# DESIGN HYDROGEOLOGIC REPORT PHASES 3 AND 4

WHITE OAK MSW LANDFILL  
HAYWOOD COUNTY, NORTH CAROLINA

RE: Response to Technical Review  
Permit to Construct  
MSW Phases 3 & 4  
White Oak MSW Landfill Permit # 44-07  
Haywood County, North Carolina

Subject: **Revisions to the *Design Hydrogeologic Report and Environmental Monitoring Plan, Phases 3 & 4* to address NCSWS Technical Review Comments dated February 9, 2009 – Doc ID 6606**  
White Oak Landfill (MSWLF – Phase 3 & 4)  
Haywood County, North Carolina  
Permit 44-07  
BLE Project Number J07-1957-02

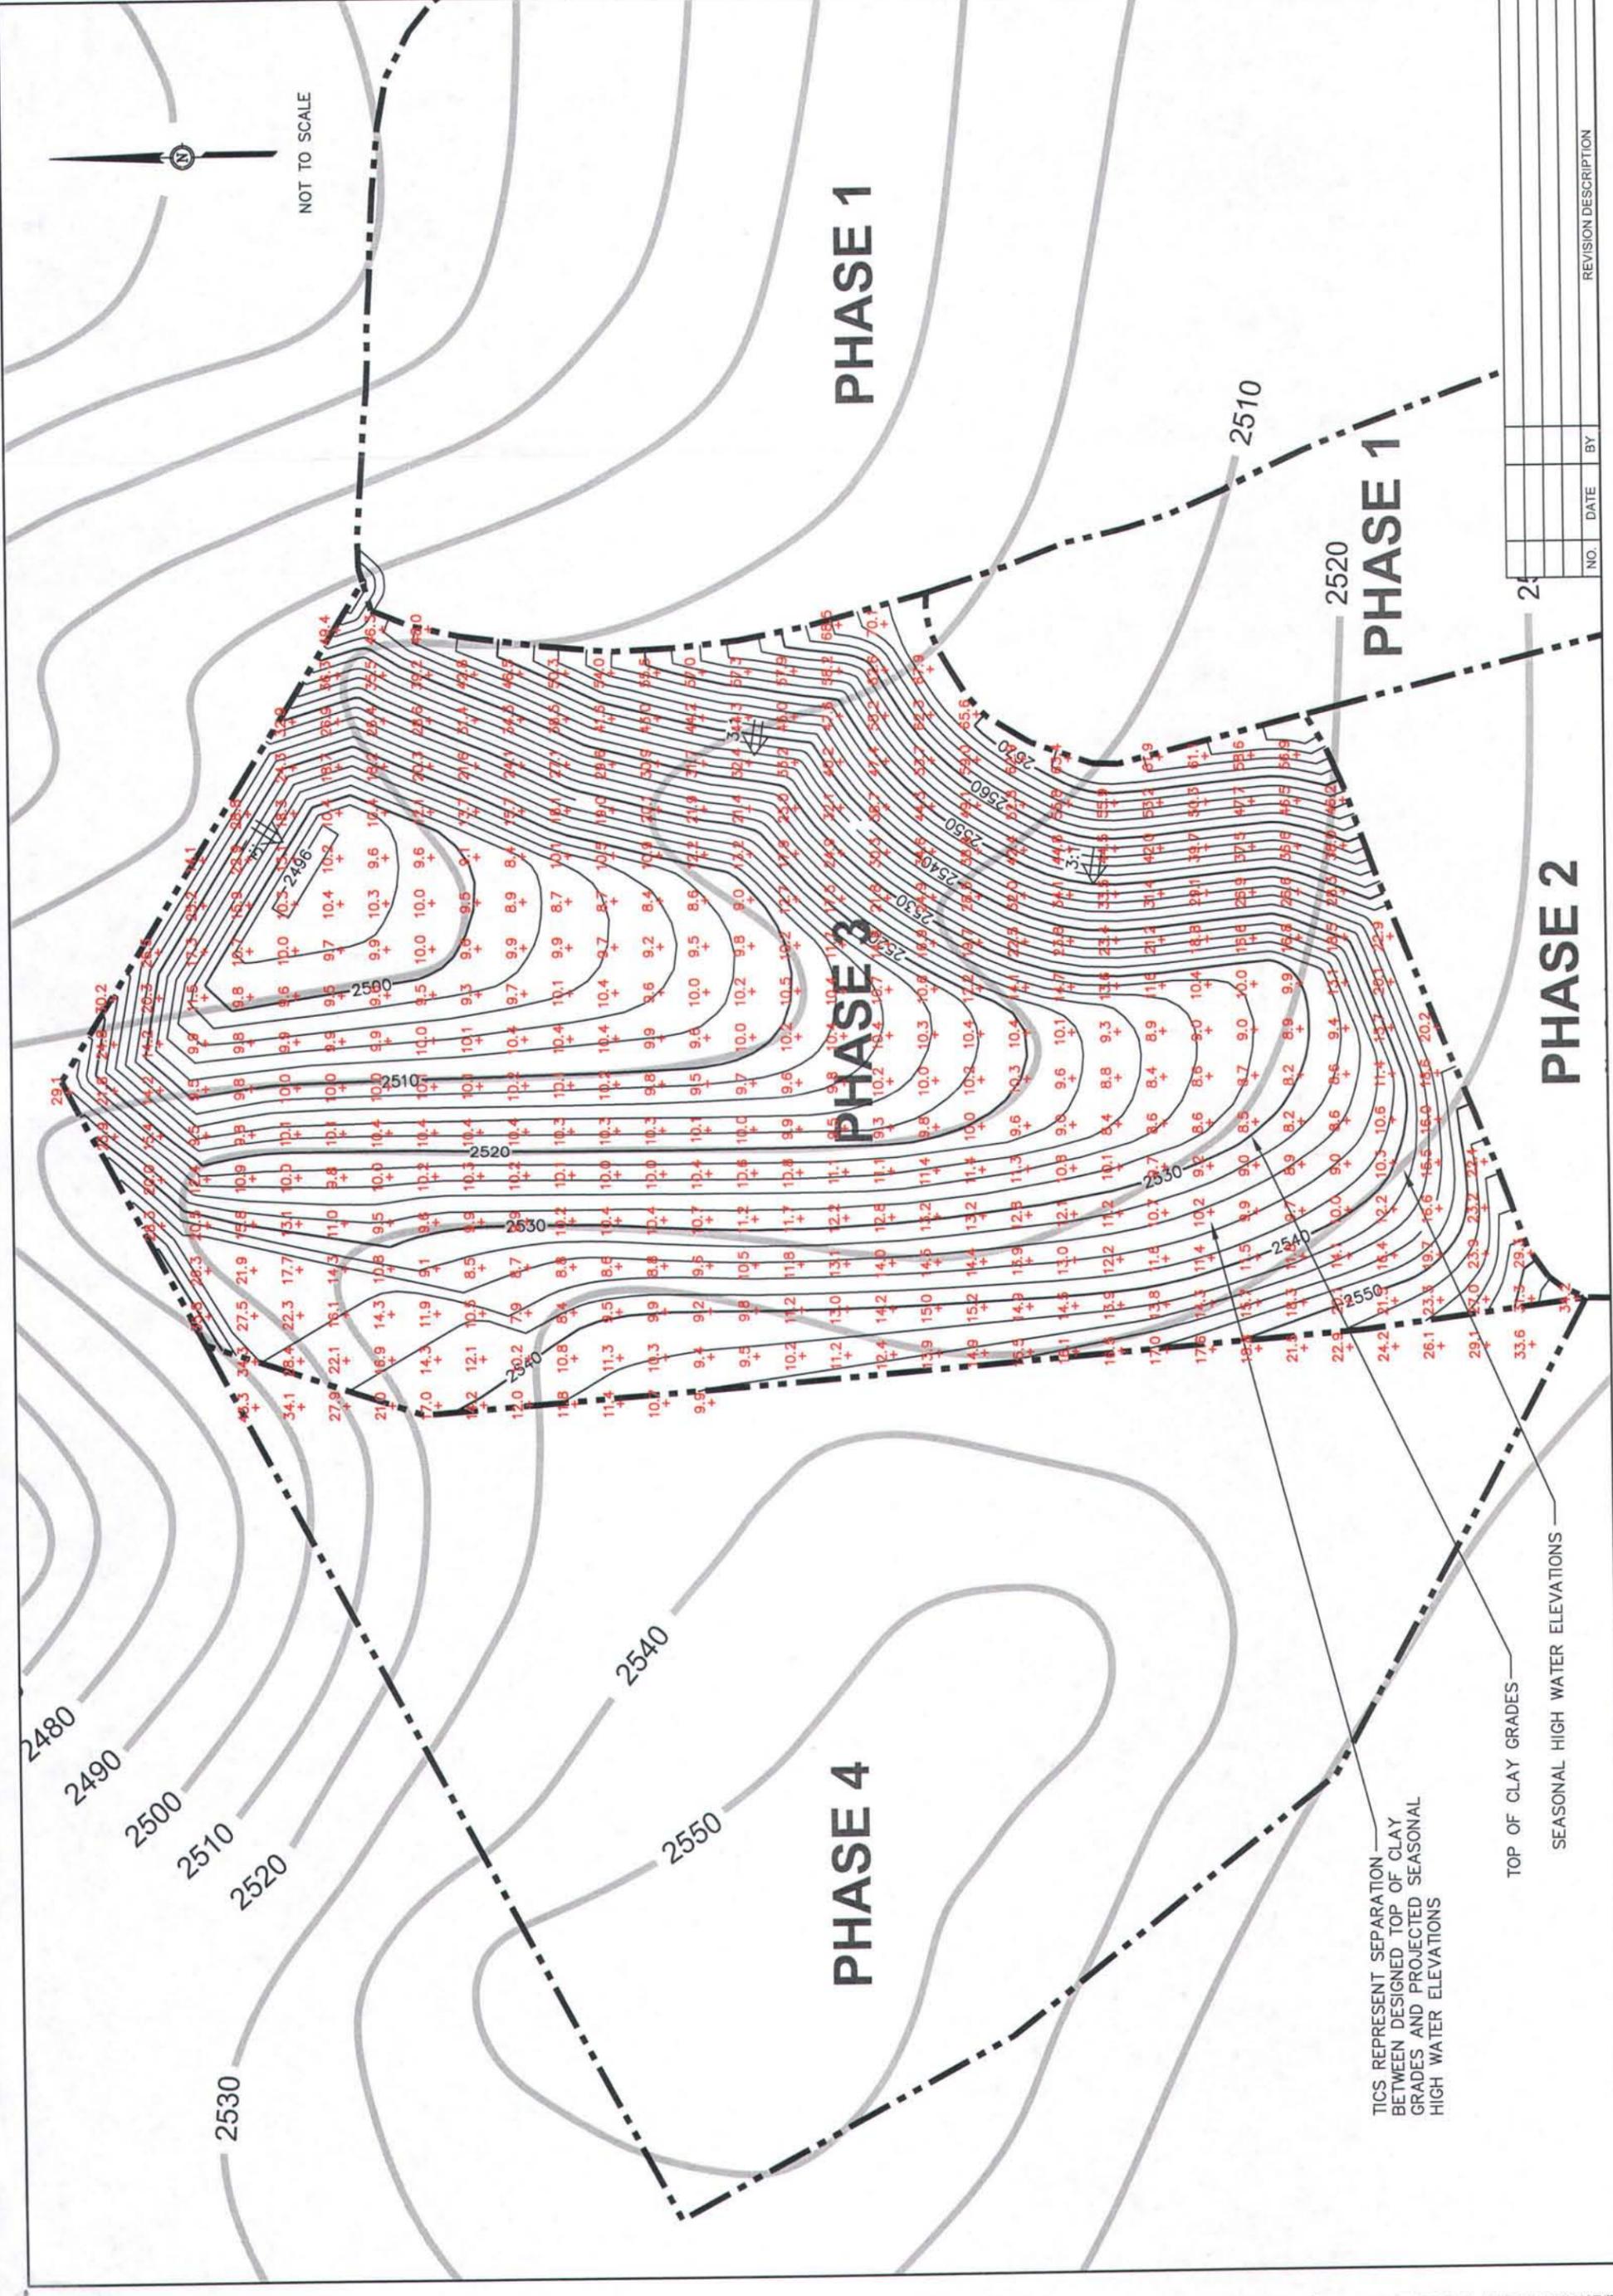
4. A certification page has been added to the front of the Engineering Plan.
5. *Rule .1620(e)(2) requires grading plans: proposed limits of excavation, subgrade elevations, boring locations, intermediate grading for partial construction. Sheet C3 shows proposed grading contours, but there is a Note within Cell 3 stating contours within Phase 3 consist of existing, proposed top of clay, ground water and rock elevations. Please provide a drawing with subgrade elevations as required.*

5. Sheet 3A, depicting the subgrade elevations within the MSW Phase 3 waste area, has been added to the Permit to Construct package. The original Sheet 3, **Phase 3 Clay Liner Grades**, has been renamed to 3B, and illustrates the top of clay elevations. Additionally, the 2496 and 2498 clay contours, in the vicinity of the sump area, have been revised to more accurately depict the contours in this area, and are shown on the enclosed Sheets 3A, 3B, and 4. Only the MSW Phase 3 drawings have been revised since a Permit to Construct will not be granted for MSW Phase 4 at this time. Additionally, Sheets 3A, 3B, and 4 have been modified to reflect the revisions of the Design Hydro Report, as noted above. The 8-foot minimum separation noted in Section 2.1 of the Engineering Plan has been maintained.

**Figure 5.** Hydrogeologic units within the Blue Ridge and Piedmont Provinces of North Carolina (from Daniel and Payne, 1990).

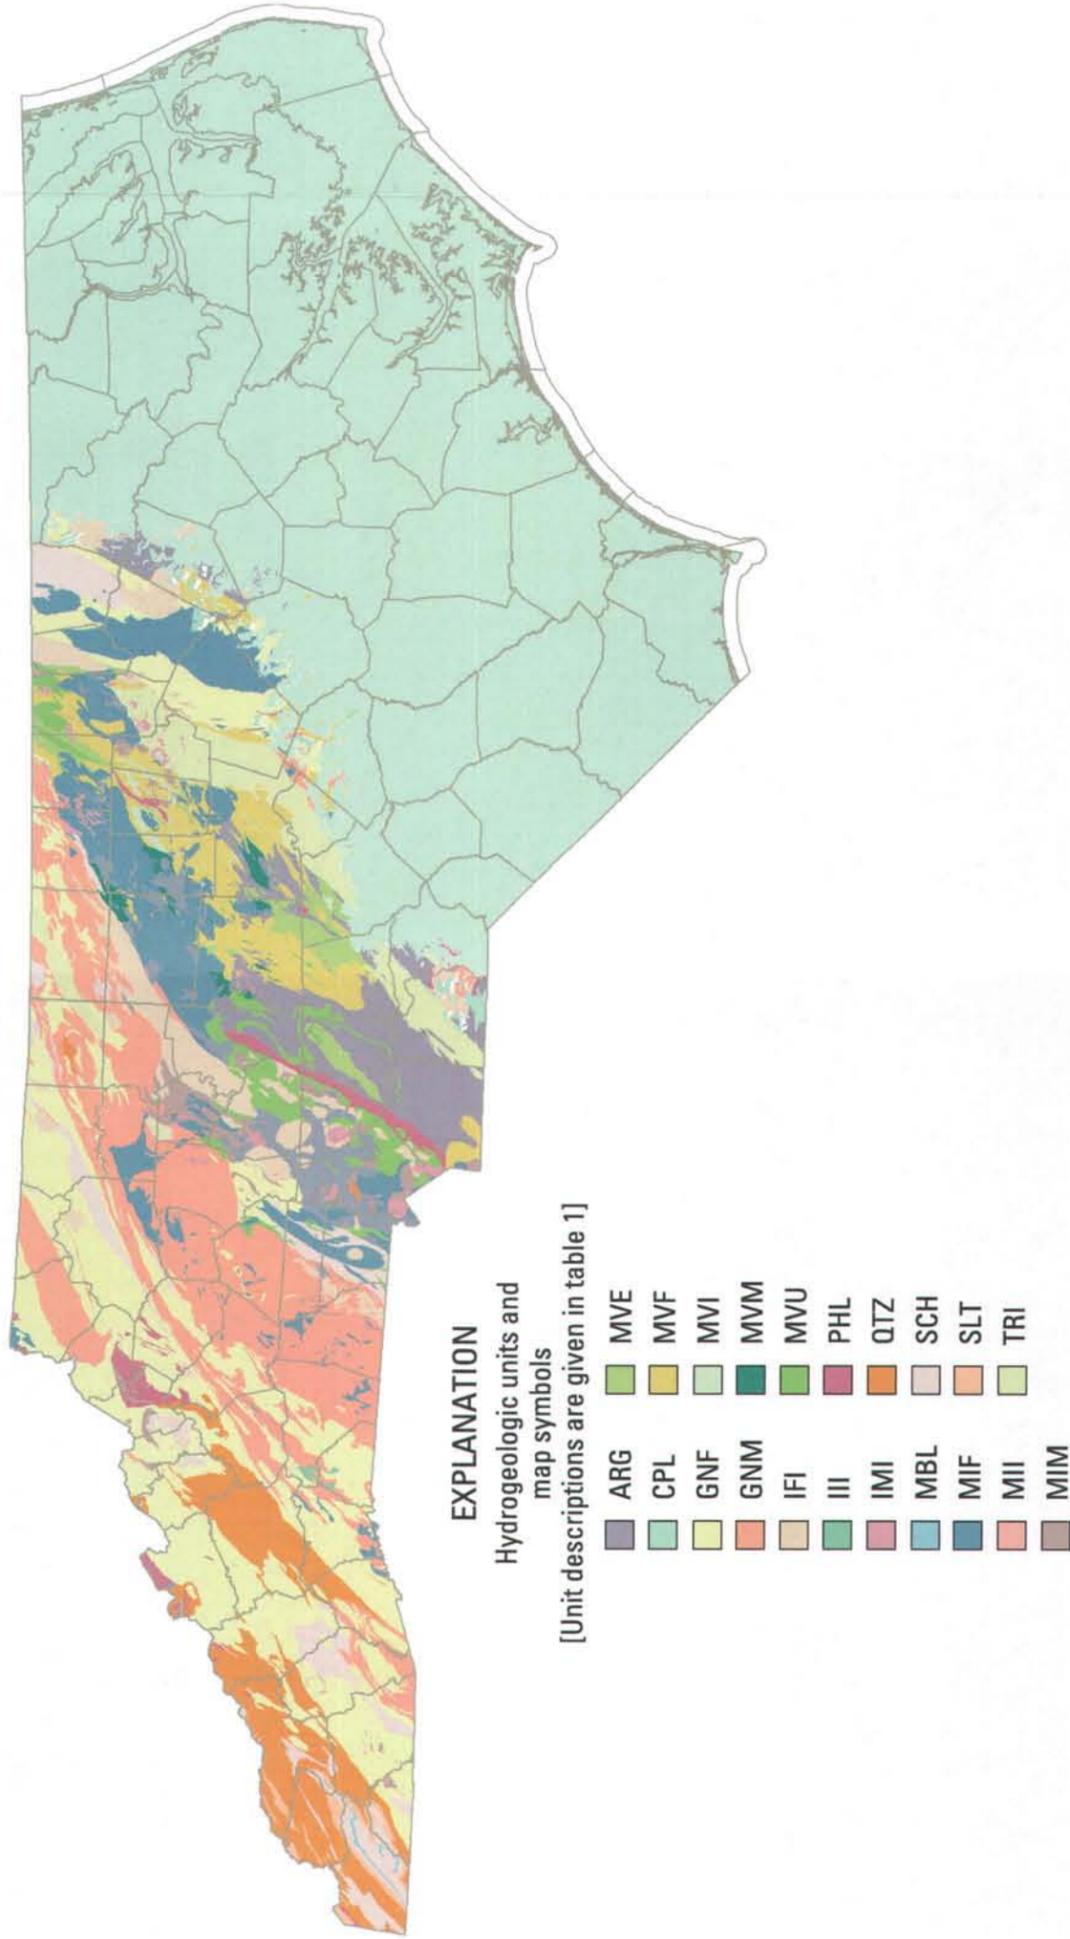
*Figure 2 Include the state hydrogeologic map, which more relevant to the report.*

We have included Figure 5 and Table 1 from the *Preliminary Hydrogeologic Assessment and Study Plan for a Regional Ground-Water Resource Investigation of the Blue Ridge Piedmont Provinces of North Carolina* (USGS Water-Resources Investigation Report 02-4105) in the DHR. The documents have been included in Appendix K (new). The state geologic map is still included in the DHR as Figure 2.
